## Product Change Notification / ASER-06FDTY754

CCB 4882 Final Notice: Qualification of CEL-8240 GS new molding compound for selected LR8Nxxx, LR645Nxxx, LR745Nxxx, LR12Nxxx, HV992xxx and TC32Mxxx device families available in 3L TO-92 package at CRTK assembly site.

**CCB 4882**  
**Pre and Post Change Summary**  
**PCN #: ASER-06FDTY754**

# Lead Frame Comparison

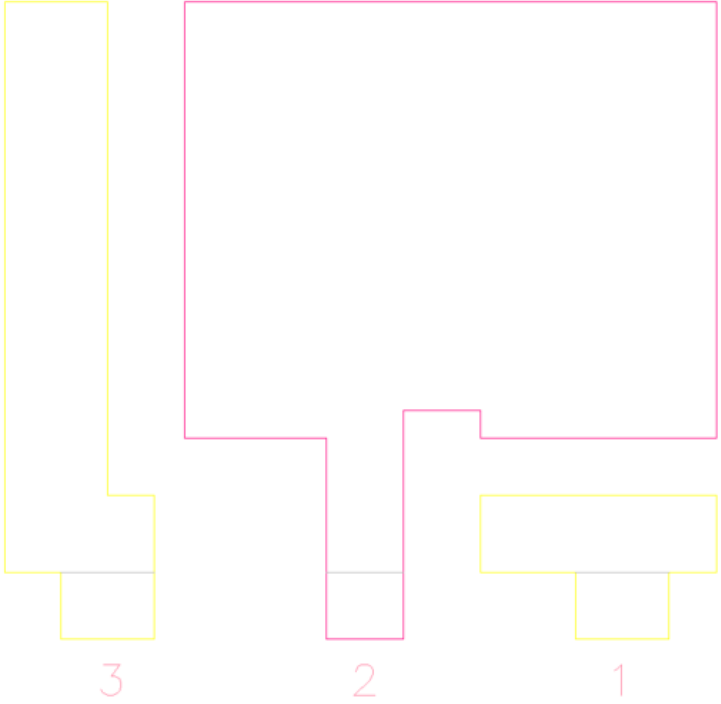
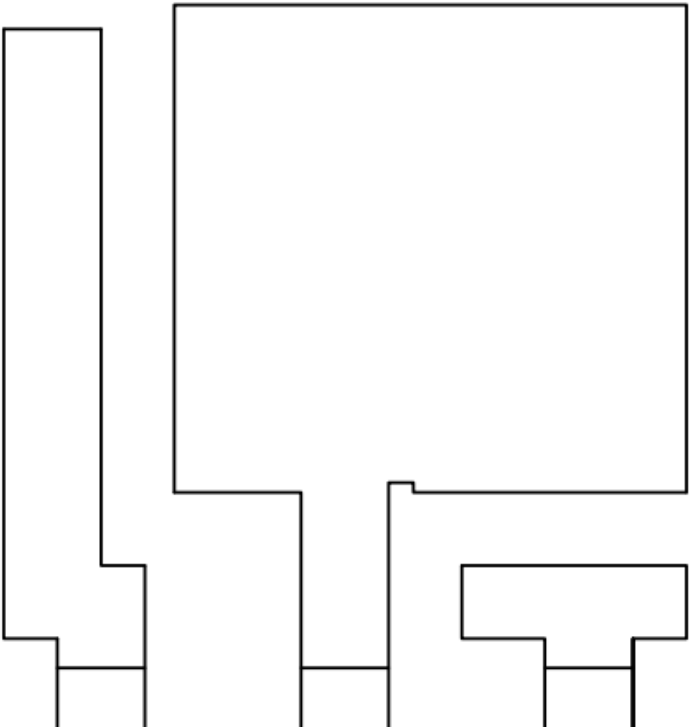
GTK		CRTK		
 <p>The GTK lead frame diagram shows three lead configurations labeled 1, 2, and 3. Lead 1 is a wide, flat paddle. Lead 2 is a narrower, stepped lead. Lead 3 is a tall, narrow lead with a small paddle at the bottom.</p>		 <p>The CRTK lead frame diagram shows three lead configurations. The left lead is tall and narrow. The middle lead is wide and flat. The right lead is a wide, flat paddle.</p>		
<b>Lead-Frame Material</b>	CDA194	<b>Lead-Frame Material</b>	Pre-Change A194	Post Change A194
<b>Lead-Frame Paddle size</b>	105x86 mil or 105x88 mil	<b>Lead-Frame Paddle Size</b>	105x100 mil	105x87 mil
